SERVICE BULLETIN

Machines Affected:
MVH-406DSY S/N's N1001 to N1003 and S/N's N1007 to N1011
MVH-306DS2 S/N's N2602 to N2611 and S/N's 2684 to 2713

It has been determined that the above referenced units have the low oil warning buzzer incorrectly wired.
 These units currently have the warning buzzer wired directly to 12V DC at all times. When battery is installed, the buzzer will sound without the engine running. In order to ensure low oil warning system is functioning properly, perform the following procedure.

Figure 1

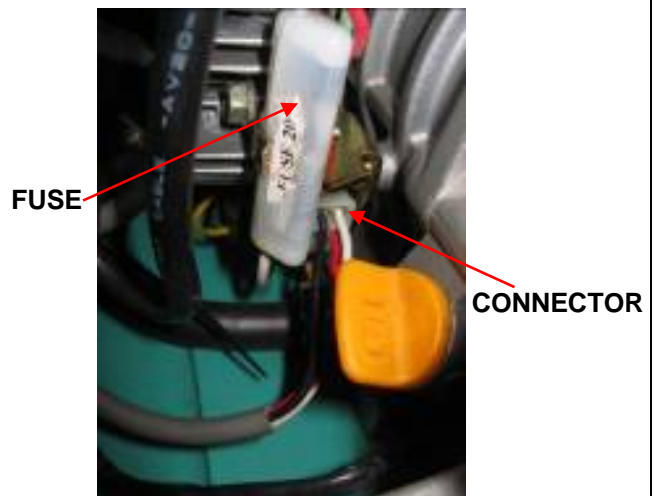
1. Locate the 3-pin connector with black, red, and white wires connected to it (Figure 1).
2. Move the fuse aside in order to gain access to the connector (Figure 1).

Figure 4

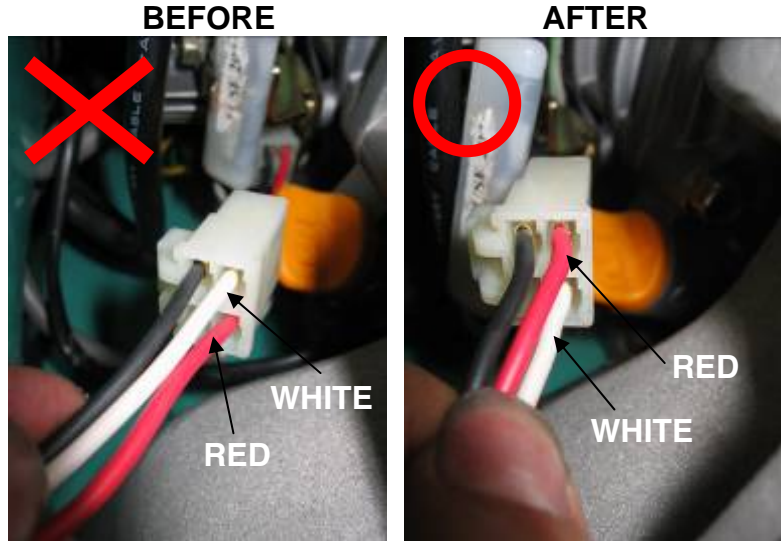
5. Switch the red and white wires so that the red wire is now next to the black wire (Figure 4).

6. Reconnect the connector and return fuse back in place.
